LiDAR Quality Assurance (QA) Report
California LiDAR and Imagery QA
NOAA Coastal Services Center
NOAA Contract: EA133C-11-CQ-0007
March 20, 2012

Submitted to:
NOAA Coastal Services Center

Prepared by:
 **Dewberry**

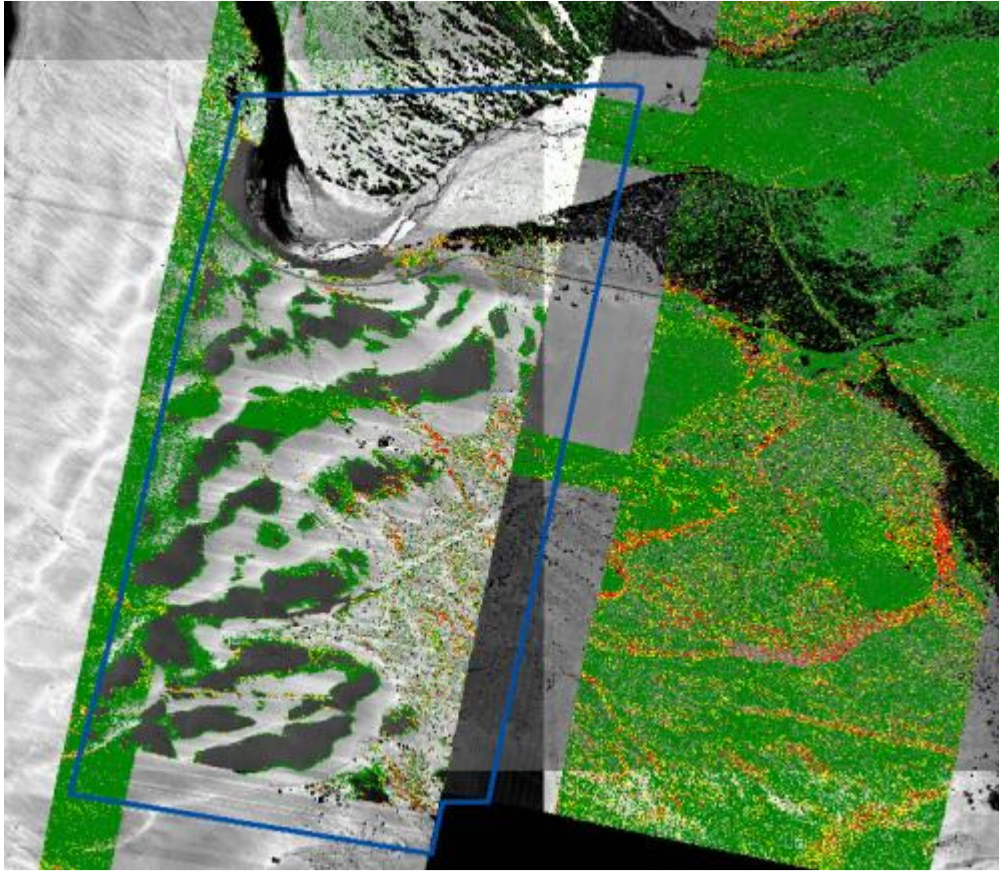
Figure 3 - The amount and placement of red and yellow pixels in the delta z ortho image above indicates the possibility of flight line offsets. Further analysis showed that two flight line ridges exist within the area outlined in blue. The remaining red areas are a product of the terrain, not an offset.

Figure 9 – Tile c7155_38820, first delivery. Ground elevation model. Changes in ground conditions between have created the unnaturally raised portion of ground seen above. Three ridges measure approximately 60 cm each.

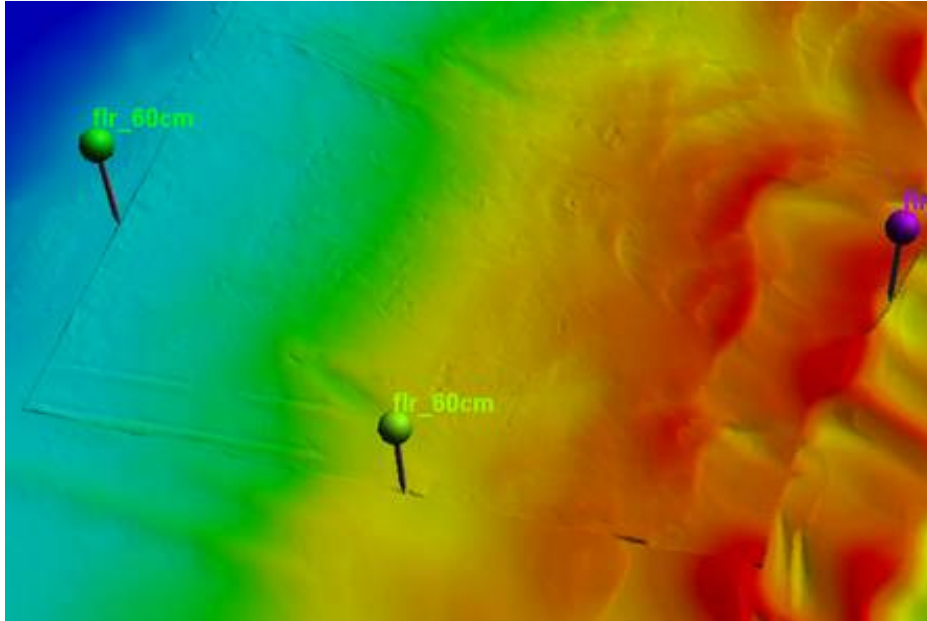
LiDAR by nature can only depict the ground surface at the time of collection. This means there is no easy fix for areas where cohesive data does not exist. Dewberry's original recommendation to the data provider was to correct large flight line ridges by using only points from the most recent flight line present in the area. For the second delivery LiDAR, the majority of flight line ridges were corrected or minimized in this way, however in some cases temporal flight line ridges that are over project specifications remain. Often the data provider was able to correct the ridge originally identified, however the correction created a second ridge nearby.

The temporal flight line ridges in the dataset cannot be fully eliminated because each flight line does not fully cover the area on its own. Because of this, Dewberry does not feel that further corrections from the LiDAR provider would be appreciably beneficial. The figures below show several examples of the flight line ridges and their corrections. Figure 9 shows a ridge that was identified in the original delivery. The GDB accompanying this report contains a shapefile identifying flight line ridges detected in the first delivery and is attributed with comments from the data provider indicating whether issues existed in correcting the ridge. Additionally, Dewberry has included 6 new temporal flight line ridge calls which resulted from correcting the original ridges. These calls are added as a reference for the user.

Figure 10 - Tile 3960_46245, first delivery. Ground density model. The image shows a large spike in elevation over the surface of the painted runway.

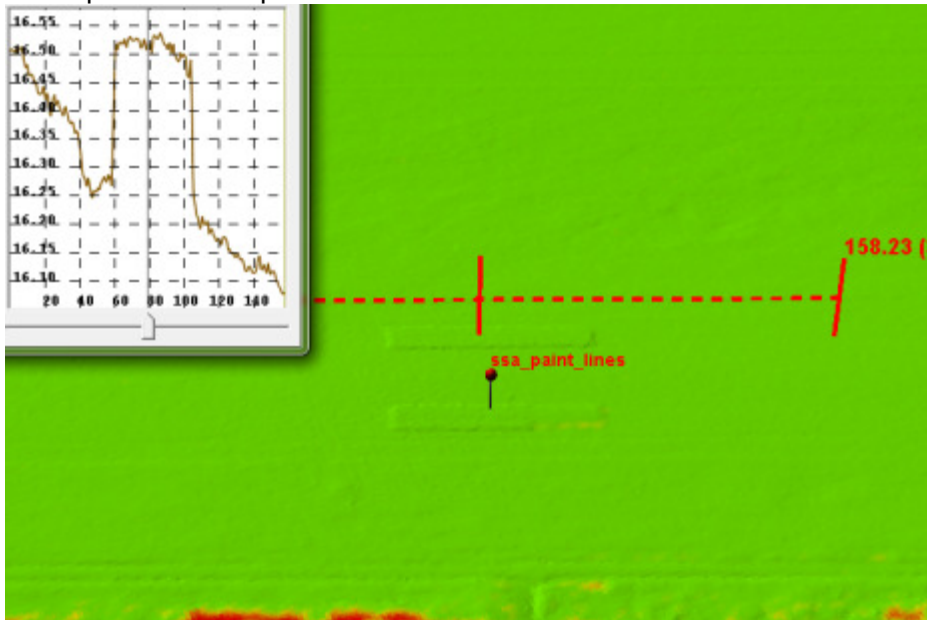
During the review Dewberry identified a few areas where reflective paint from an airport runway caused a sensory anomaly leading to an inaccurate portrayal of the ground model. These points should be moved from ground (class 2) to unclassified (class 1). These areas were corrected by FEDI in the subsequent deliveries of the dataset. An example is shown below and a GDB that contains the location of the edit calls accompanies this report.

Figure 17 - Tile C4620_36765. Pond, in purple, shown overlaid first with a GeoTerrain built from ground points in the LAS.

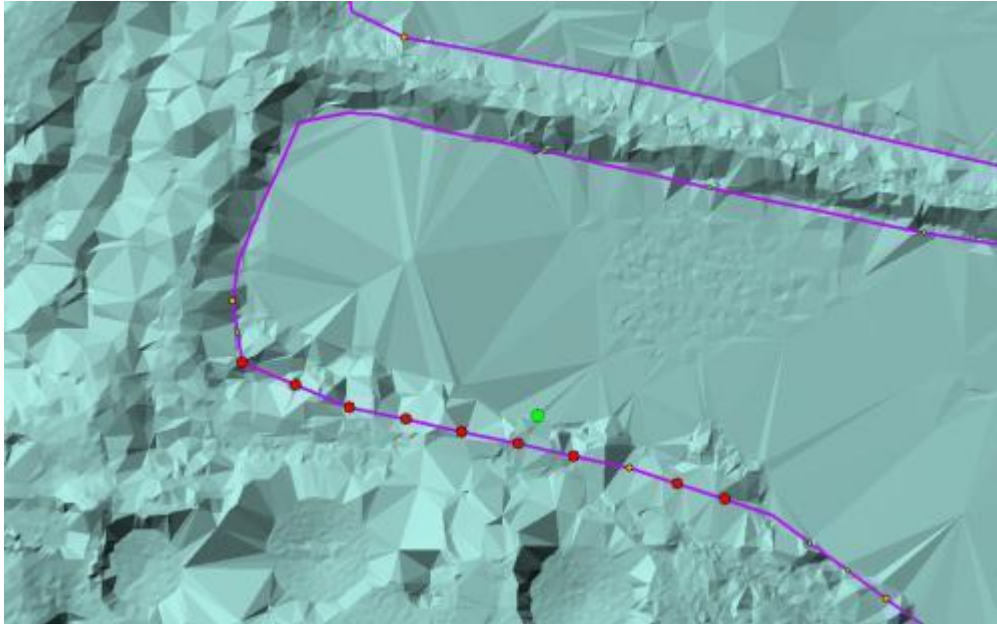
In the review Dewberry identified vertices in seventy-five (75) breakline features that dig into the terrain surface. These vertices have a direct impact on the DEM. Figure 17 show several vertices in the pond bank digging by up to 2.6 meters, shown in red. Upon review of full point cloud intensity image and ortho image, it was determined that there is some degree of tree overhang in this area but not to the degree shown here. Dewberry confirms that FEDI has adjusted the all the breaklines so that they no longer dig into the surrounding terrain.
